STERLING RANCH FILING NO. 2

FINAL PLAT
STERLING RANCH FILING NO. 2
JOB NO. 25188.01
01/21/2021
SHEET 1 OF 7

FILE NO. SF-20-015

FINAL PLAT
STERLING RANCH FILING NO. 2
JOB NO. 25188.01
01/21/2021
SHEET 3 OF 7

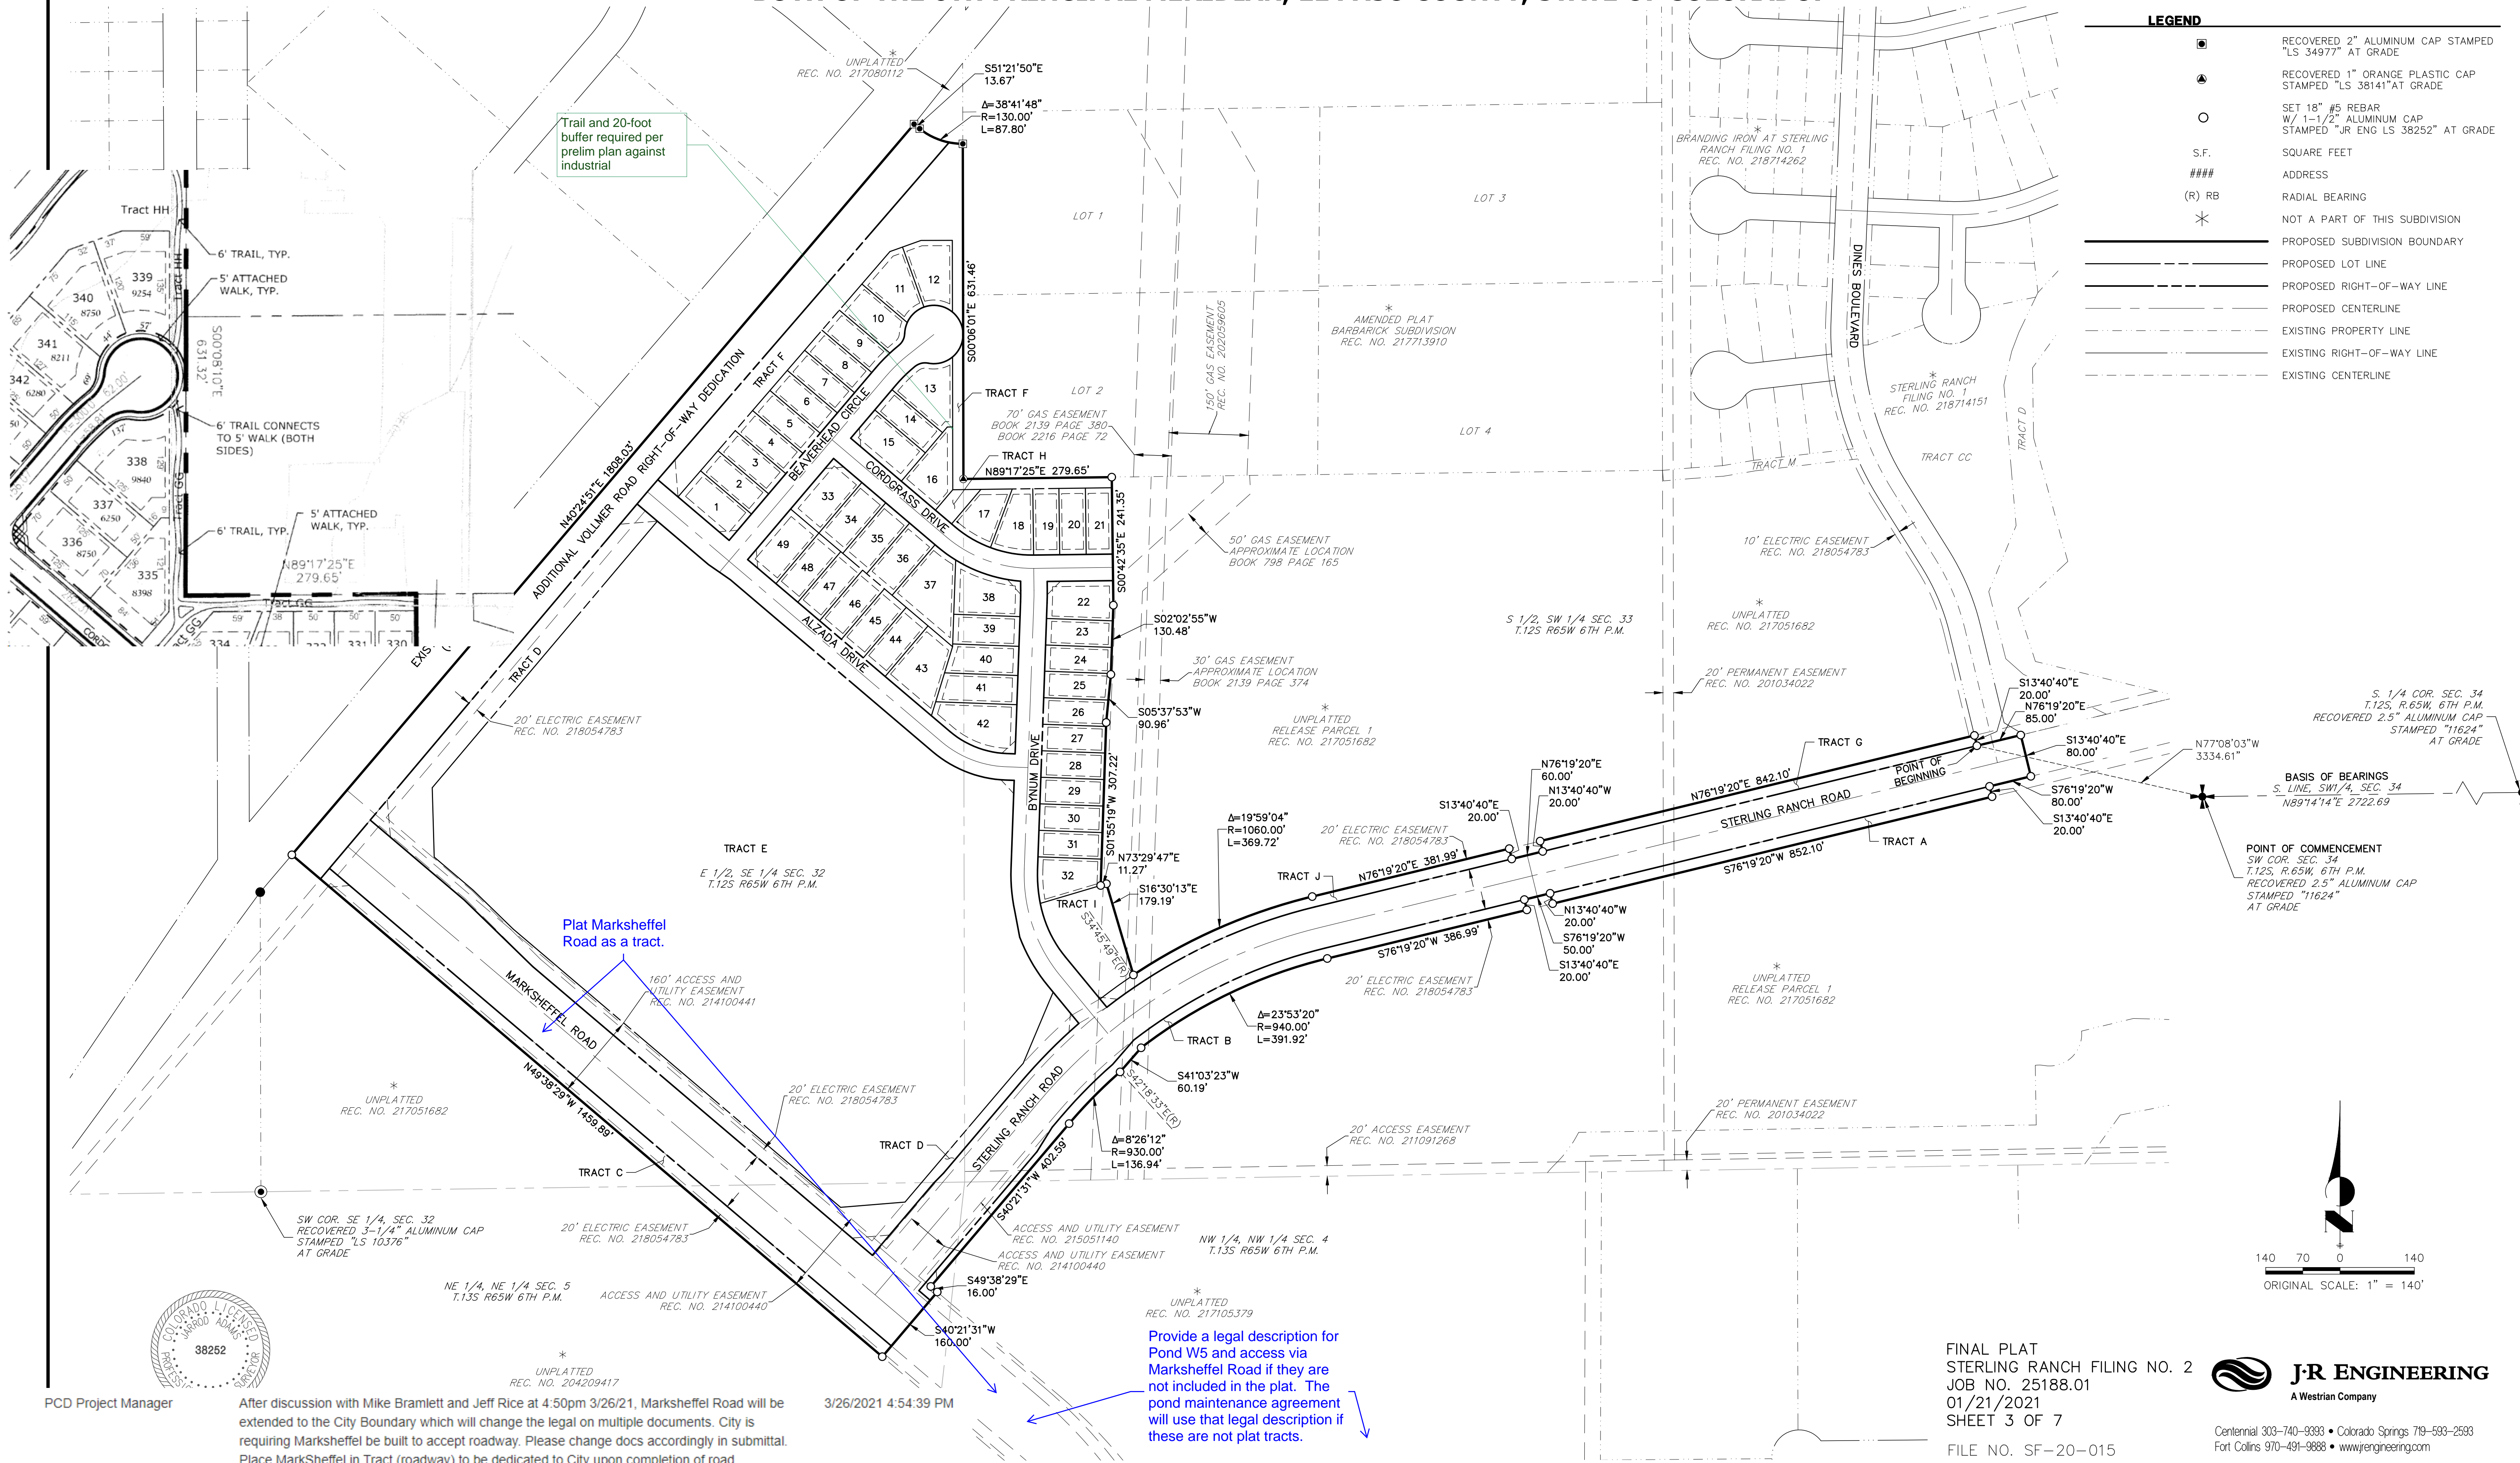
Trail and 20-foot buffer required per prelim plan against industrial

Plat Marksheffel Road as a tract.

Provide a legal description for Pond W5 and access via Marksheffel Road if they are not included in the plat. The pond maintenance agreement will use that legal description if these are not plat tracts.

After discussion with Mike Bramlett and Jeff Rice at 4:50pm 3/26/21, Marksheffel Road will be extended to the City Boundary which will change the legal on multiple documents. City is requiring Marksheffel be built to accept roadway. Please change docs accordingly in submittal. Place MarkSheffel in Tract (roadway) to be dedicated to City upon completion of road.

FINAL PLAT
STERLING RANCH FILING NO. 2
JOB NO. 25188.01
01/21/2021
SHEET 4 OF 7

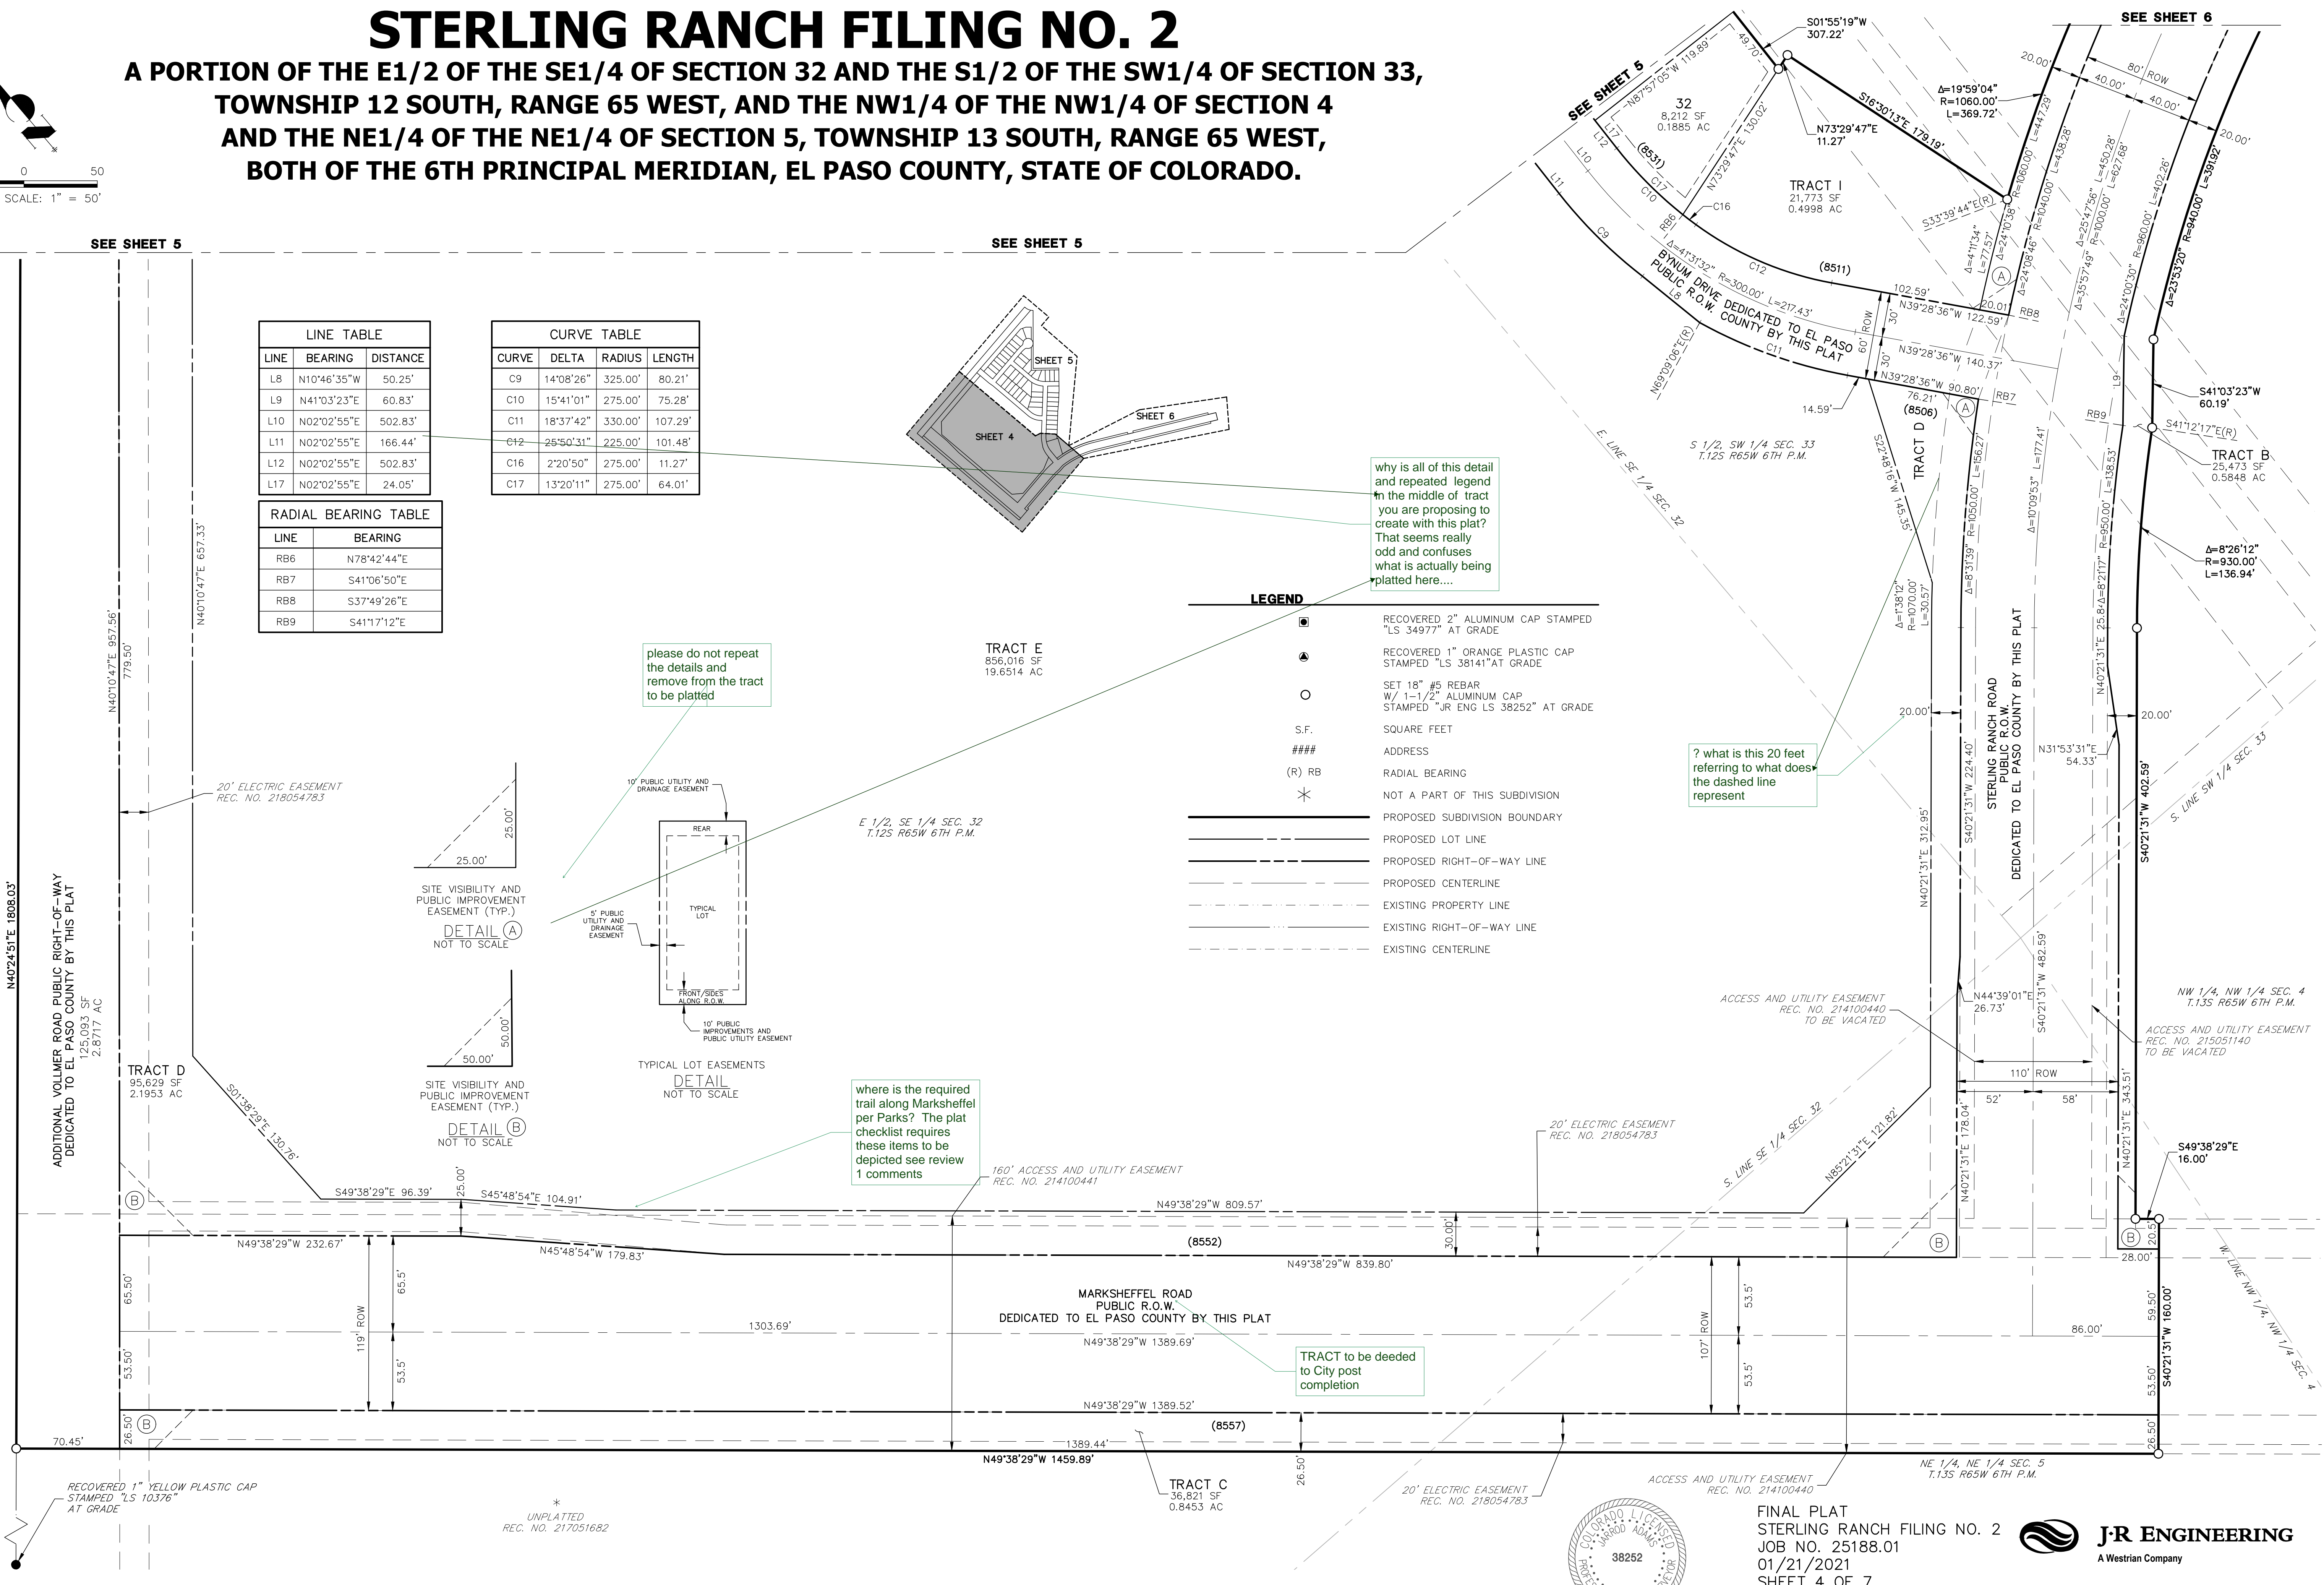
why is all of this detail and repeated legend in the middle of tract you are proposing to create with this plat? That seems really odd and confuses what is actually being platted here....

please do not repeat the details and remove from the tract to be platted

? what is this 20 feet referring to what does the dashed line represent

where is the required trail along Marksheffel per Parks? The plat checklist requires these items to be depicted see review 1 comments

TRACT to be deeded to City post completion
